**DESIGN OF FIRE SPRINKLER SYSTEM
FOR THE TECHNICAL EDUCATION SHOPS AT
OLIVER WOLCOTT REGIONAL VOCATIONAL TECHNICAL
HIGH SCHOOL
TORRINGTON, CONNECTICUT
PROJECT: BI- RT- 853**

ADDENDUM NUMBER 1

November 14, 2011

5 TYPICAL THRUST BLOCK DETAIL

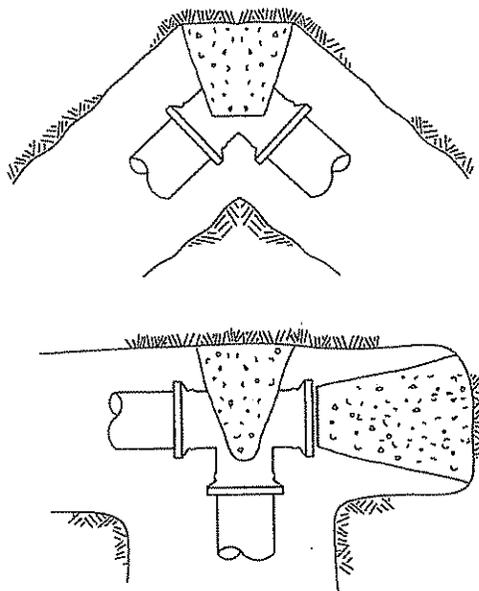
Drawing FP-1, FIRST FLOOR AREA A FIRE PROTECTION PLAN AND SITE PLAN, dated June 23, 2010, **ADD** Detail 5 - Typical Thrust Block Detail see attached sketch SKFP-1.

NOTE: PROVIDE THRUST BLOCKS AT ALL PIPE TURNS AND PIPE FITTINGS OF NEW UNDERGROUND FIRE SERVICES AND FIRE MAINS.

2 PARTIAL BASEMENT AREA B FIRE PROTECTION PLAN
 SCALE: 1/8"=1'0"

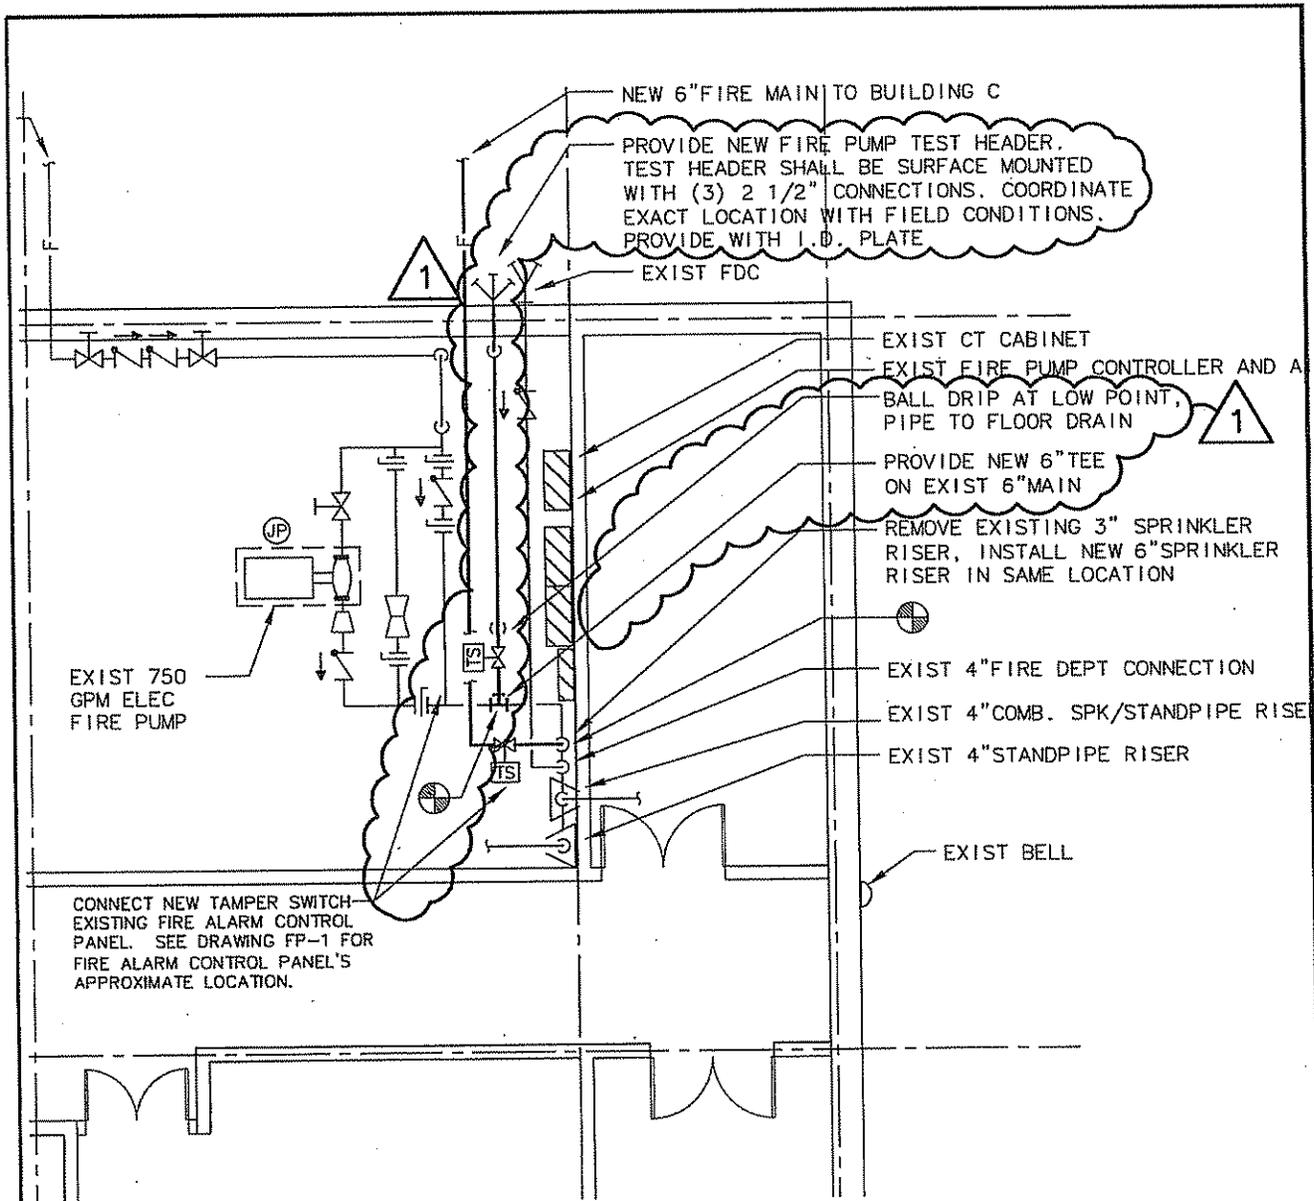
Drawing FP-4, FIRST FLOOR AREA G AND PARTIAL BASEMENT AREA B FIRE PROTECTION PLANS, dated June 23, 2010, **REVISE** the drawing as indicated on the attached sketch SKFP-2.
